Comment 38 - request to exit LPI

April 2019

Comment 38

Figure 149–15—PCS 64B/65B Transmit state diagram, part b

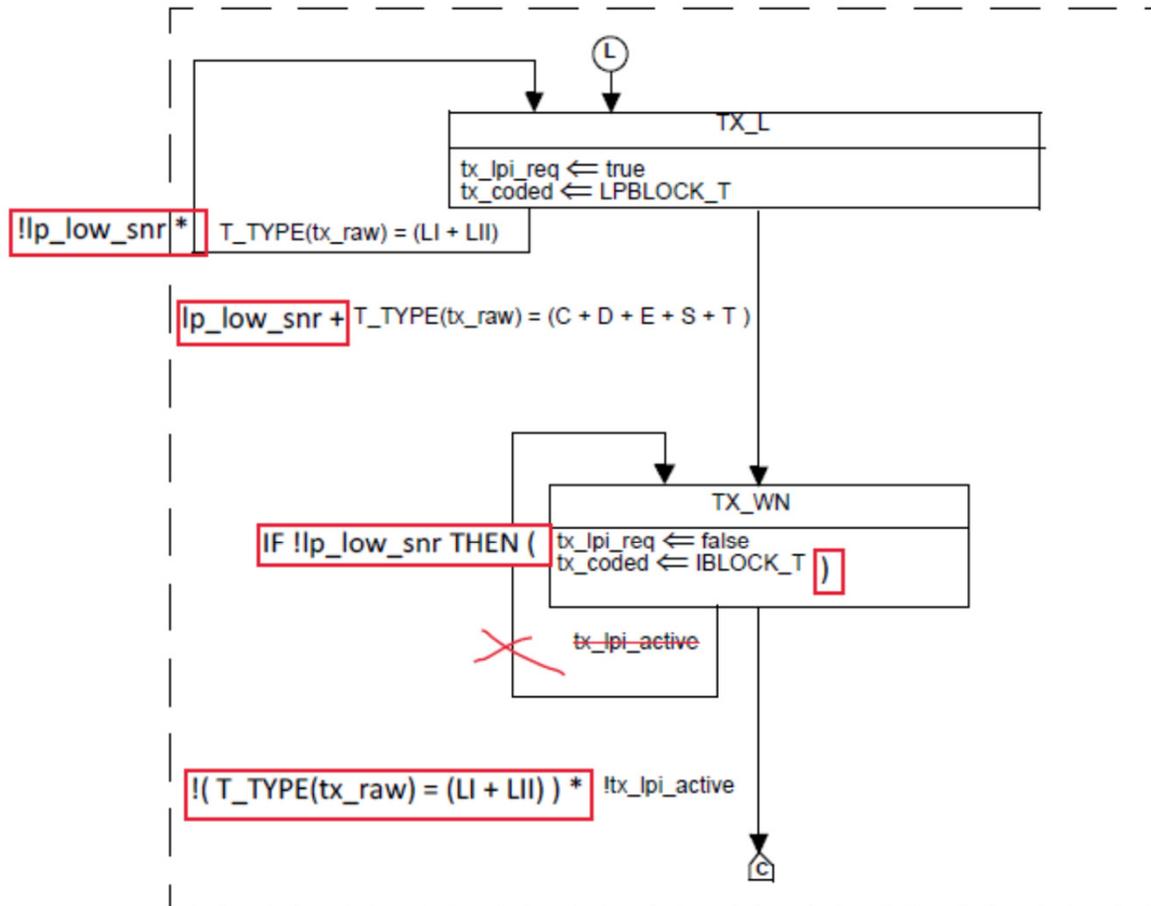
- ▶ Modify Fig 149–15 (PCS 64B/65B Transmit state diagram) as follows:
 - Change the assignment inside state TX_L to prevent entering LPI
 - IF !`lp_low_snr` THEN (`tx_lpi_req` <= true
`tx_coded` <= LPBLOCK_T)

- Change the transition condition from TX_L to TX_WN to exit LPI for low SNR
`lp_low_snr + T_TYPE(tx_raw) = (C + D + E + S + T)`
 - Change the transition condition from TX_L to TX_L to balance other path
`!lp_low_snr * T_TYPE(tx_raw) = (LI + LII)`

- Change the transition condition from TX_WN to TX_C, wait for RS to stop LPI
`!tx_lpi_active * !(T_TYPE(tx_raw) = (LI + LII))`
 - Remove the loopback path from TX_WN to TX_WN, it is unnecessary.

Changes to Figure 149–15

- ▶ When the link partner indicates low SNR, the TX state machine will gracefully exit low power idle and stay in the Wake state sending Idles until the RS stops indicating LPI on the XGMII.
- ▶ Upon exit from Wake into normal Idle/Data, if the RS again presents LPI at the XGMII the TX state machine will not send the SLEEP signal and will not enter the low power idle state, but instead move to the Wake state and send Idles until the RS stops sending LPI.
- ▶ With these changes on the TX PCS side, no modifications are needed on the RX side and no changes are needed to the EEE state machine.
- ▶ There is no interruption to data in the receive path.
